218 S LAMAR BLVD (SCHLOTZSKY PUD) REZONING (C814-2018-0121)
COMMENTS FROM ZILKER NEIGHBORHOOD ASSOCIATION
(July 24, 2020)

**PROJECTED TRAFFIC FLOW FROM SCHLOTZSKY PUD ONLY
(ONE ENTRANCE/EXIT)**

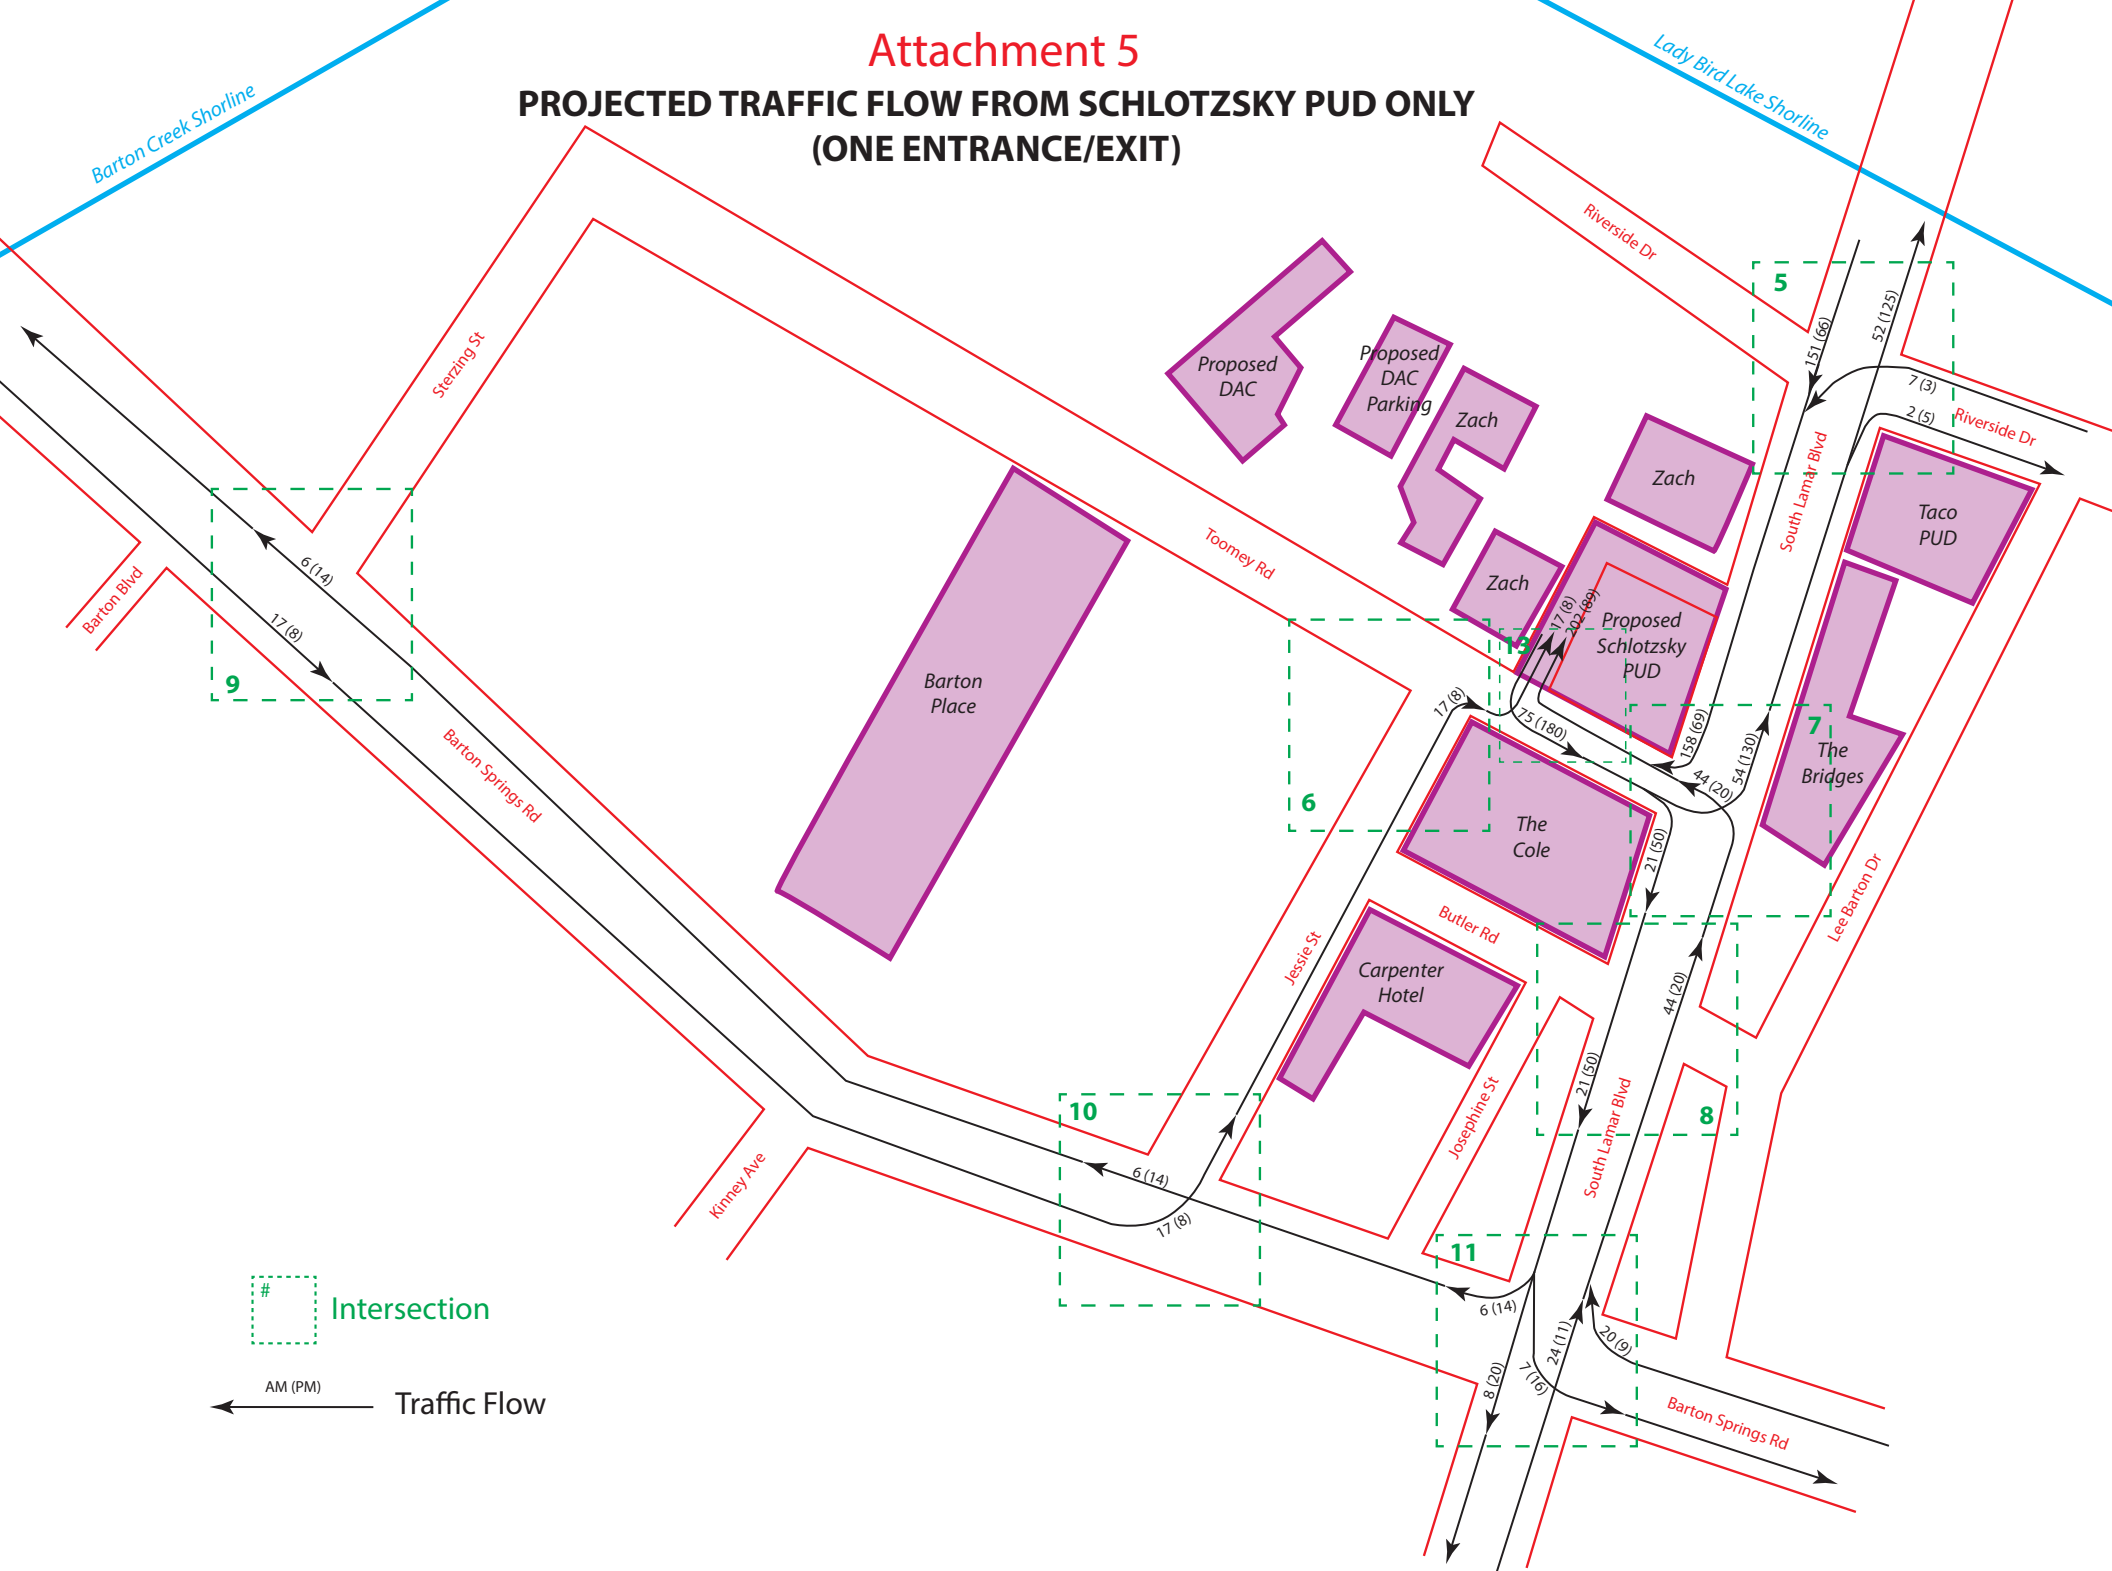
6) The projected traffic flow (see Attachment 5) is unreasonable. Even if only 8% of the trips to and from the site utilize Barton Springs Rd (west), and this seems like an extremely low number of trips, cars are very unlikely to take the path that is projected in the TIA, especially when leaving the site. Virtually no one is going to turn left onto Toomey, right onto South Lamar, and then right onto Barton Springs Rd. Instead, they will turn right onto Toomey, left onto Jessie or Sterzing, and then right onto Barton Springs, thus avoiding two signals and the South Lamar traffic.
